This new version replaces all previous versions. Please replace SI-190722

"Electrical actuator failure" after ignition ON
requires action code from the vehicle manufacturer!

Vehicle Manufacturer: Audi, VW, Skoda, Seat
Vehicle: 1.2 TSI, 1.4 TSI / TFSI, 1.8 TSI
Motorcode: CBZA, CBZB, CBZC

Illustration T916401

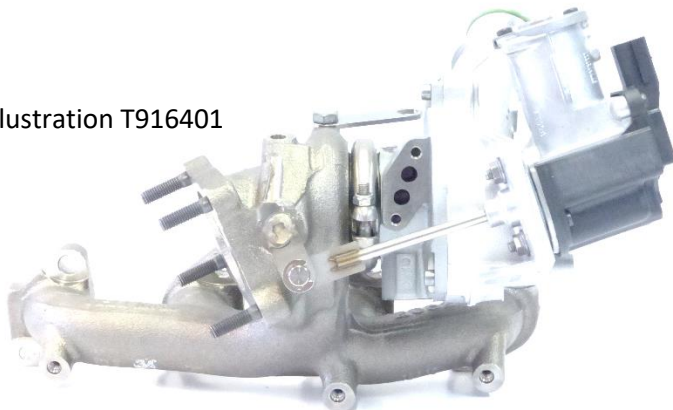
In the history of vehicle manufacturers, there have been technical changes to the turbocharger's electrical actuator. Only turbochargers according to the latest state of development are supplied.

Whether an update of the motor control software is necessary in the course of an action code is shown after resetting the teach-in values and when teaching the actuator. If the "Error in electrical actuator turbocharger" is set in the fault memory after the ignition is ON, the problem is not a defect in the turbocharger, but the need to carry out a software update with activation of the adaptation according to the action code.

The built-in turbocharger is an original part. It only differs on the nameplate.

The software update with activation can only be carried out by the vehicle manufacturer. There is a suitable action code for each vehicle type.

**Observe and implement the
vehicle manufacturer's
action code**
